APPLICATION NO.	FILING DATE	FIRST NAMED INVENTOR	ATTORNEY DOCKET NO.	CONFIRMATION NO.
09/584,248	05/31/2000	Annegret Janssen	96-082-1-US-01	3770

Office Action Summary

DETAILED ACTION

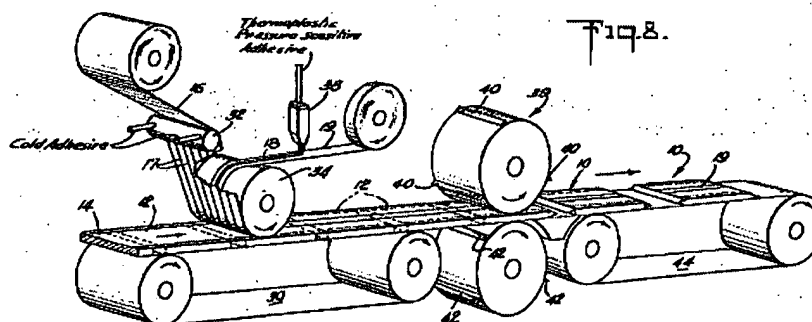
Sargent et al. disclose a coating method wherein a hot melt adhesive, made thermally flowable (column 3, lines 40-45), is provided in the form of a substantially continuous nonporous stripe 18 (Figures 3 and 18) without contact between the film 18 and the substrate 19 (see Figure 8 showing the nozzle 38 spaced from the substrate 19), and said film 18 is then disposed upon a release-coated substrate comprising a web 19 (column 4, lines 48-57) and is then transfer-coated onto a second substrate 16, i.e., an absorbent pad (column 4, lines 57-59). The method of Sargent is illustrated below:

Although Sargent et al. does not specifically disclose that the adhesive 18 is applied as a "film", it would have been obvious to one of ordinary skill in the art at the time of invention to apply the adhesive 18 of Sargent in the form of a film onto the release-coated substrate motivated by the fact that Dare et al., also drawn to methods for the disposal of an adhesive onto an absorbent pad from a release liner which has been provided with adhesive via extrusion, discloses that the adhesive may be applied in the form of an adhesive film (column 5, lines 1-19).
